# SERVICE BULLETIN

SUBJECT: INTRODUCTION OF FIBREGLASS RUDDER TIP FAIRING

Installation of Rudder Tip Fairing
Figure 1

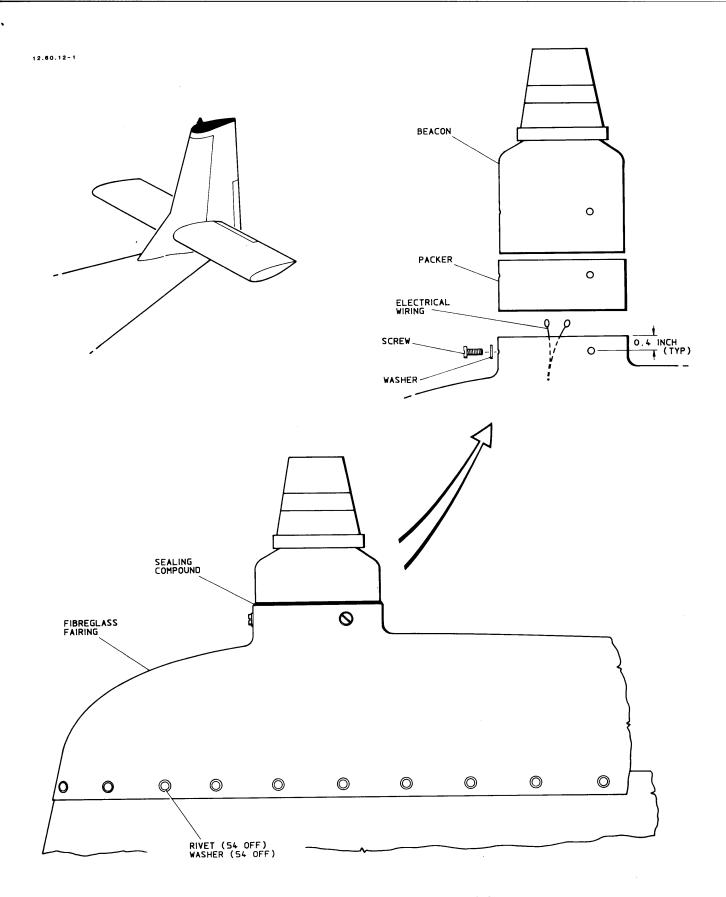
Following some reports of cracks in the ABS plastic material at the beacon mounting location a stronger fibreglass rudder tip fairing is fitted.

The ABS plastic fairing is removed and replaced with a fibreglass fairing with a packer fitted between the fairing and the beacon.

- A. Remove the rudder from the aircraft (Ref MM 55-40-00).
- B. Remove the rudder tip fairing (Ref Figure 1)
  - (1) Remove the anti-collision beacon (Ref MM 33-40-00).
  - (2) Drill out the 54 rivets retaining the rudder tip fairing to the rudder tip. Remove and discard the fairing.

- C. Fit the fibreglass rudder tip fairing
  - (1) Locate the fibreglass rudder tip fairing on the rudder tip. Using a hole locater and a No.30 (3.30 mm) drill, drill the 54 holes in the rudder tip fairing using the existing holes in the rudder tip mounting flange as a guide.

- (2) Using a 5/32 inch (4.0 mm) drill, drill one hole in the front of the beacon mounting flange on the rudder tip fairing 0.4 inch from the top edge. Using one of the pre-drilled holes in the packer P/N 1A/N-03-679, attach the packer to the inside of the beacon mounting aperture with a service bolt, or other suitable fastener. Drill the remaining two holes through the packer (pre-drilled) and the fairing using the packer as a drill guide.

- (4) Refit the fibreglass rudder tip fairing to the rudder tip and rivet up using rivets P/N CR3223-4-2 and washers AN960-PD4. The washers are installed under the heads of the rivets.

- (5) Reconnect the electrical wiring to the beacon and then install the packer and beacon into the aperture in the rudder tip fairing with the three screws and washers removed in Para 2A.(1).

- (6) Clean the area around the joint between the beacon, packer and fairing with petroleum ether and, when dry, seal with a fillet of PR 1422-B2 or suitable alternative. Remove surplus sealant before it cures using a soft cloth soaked in petroleum ether.
